MORGAN SHEET METAL ADDITION

SEDGWICK COUNTY, KANSAS

Re: S/D 96-59 Final Plat of the MORGAN SHEET METAL ADDITION

STAFF REPORT
(Final Plat Approved 9/5/96)

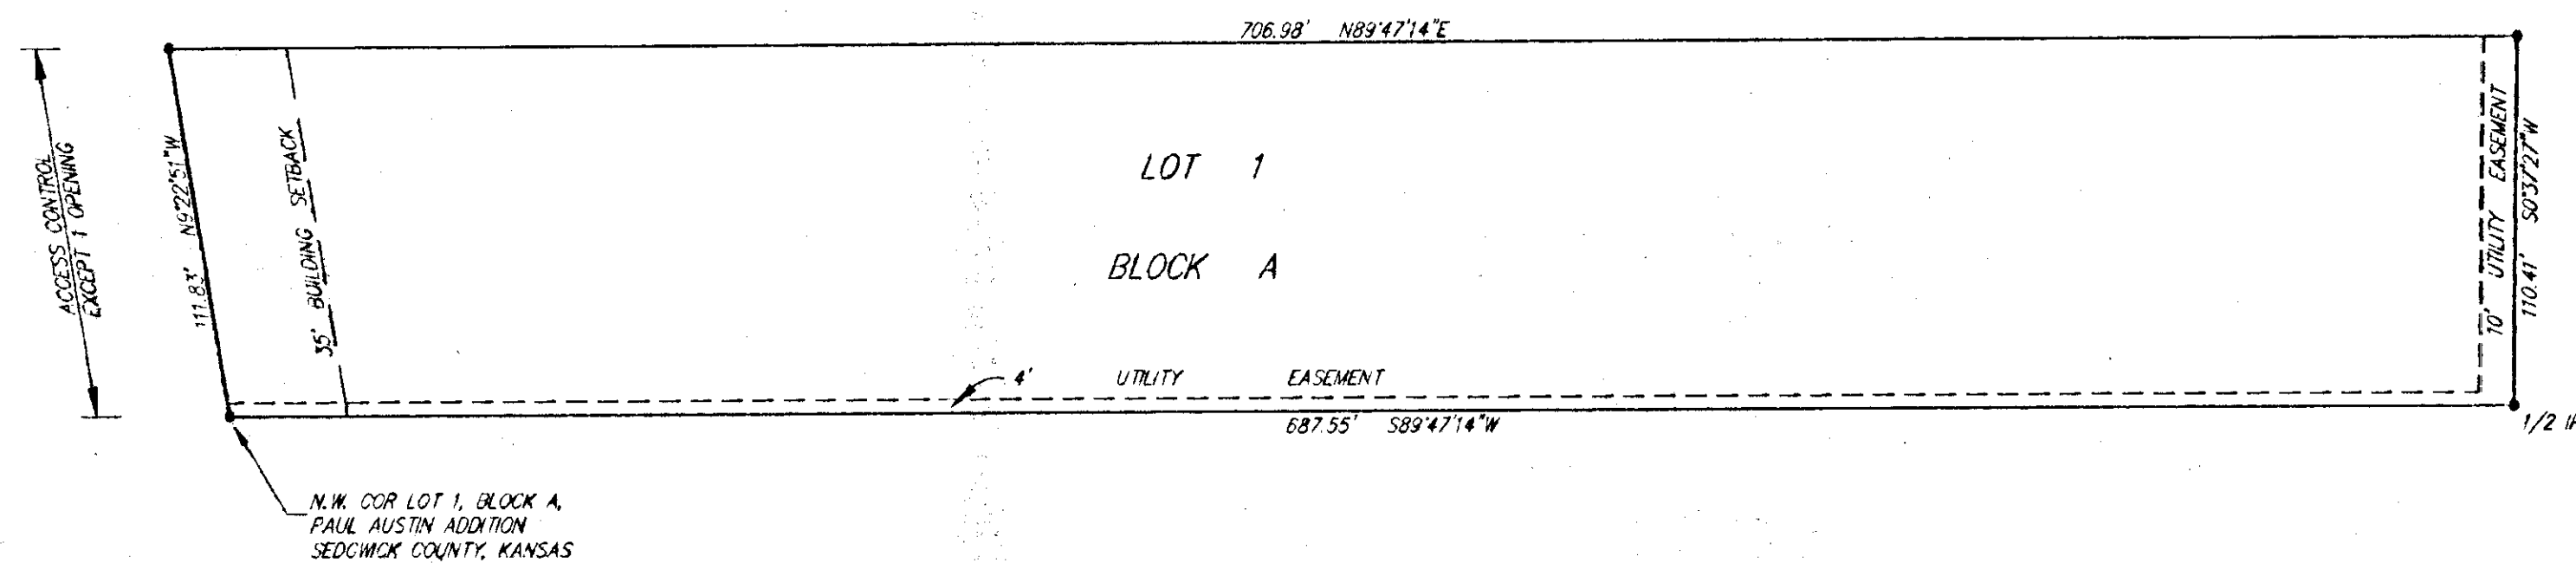
- A. Prior to this plat being scheduled for City Council review, the applicant shall submit a letter from Oaklawn indicating that arrangements have been made for this site to connect to the Oaklawn sanitary sewer system.

- B. The applicant shall guarantee any drainage improvements required by the platting of this property.
- C. If improvements are guaranteed by petition, a notarized certificate listing the petitions shall be submitted to the Planning Department for recording.

- D. The final plat tracing shall indicate the platting of the 35-foot building setback from K-15 through the existing building which encroaches into the setback area. While the platting of this building setback does not preclude the property owner from maintaining or remodeling that portion of the building within the setback area. The building cannot, however, be enlarged within the setback and, if the building is removed, any new building construction must observe the platted building setback.

- E. The final plat shall reference a tie point to a previously platted lot corner or section corner.
- F. On the final plat tracing, the legal description shall be corrected to note "the south 110.4 feet..." (not fet).

- G. The applicant shall submit an avigational easement covering all of subject plat and a restrictive covenant assuring that adequate construction methods will be used to minimize

the effects of noise pollution in the habitable structures constructed on subject property.

- A.* The applicant shall install or guarantee the installation of all utilities and facilities which are applicable and described in Article 8 of the MAPC Subdivision Regulations. (Water service and fire hydrants required by Article 8 for fire protection shall be as per the direction and approval of the Chief of the Fire Department.)
- A.* The applicant's engineer is advised that the Register of Deeds is requiring the name(s) of the notary public, who acknowledges the signatures on this plat, to be printed beneath the notary's signature.
- B.* Perimeter closure computations shall be submitted with the final plat tracing. Section 5-101(c).
- K.* Recording of the plat within 30 days after approval by the City Council and/or County Commission.
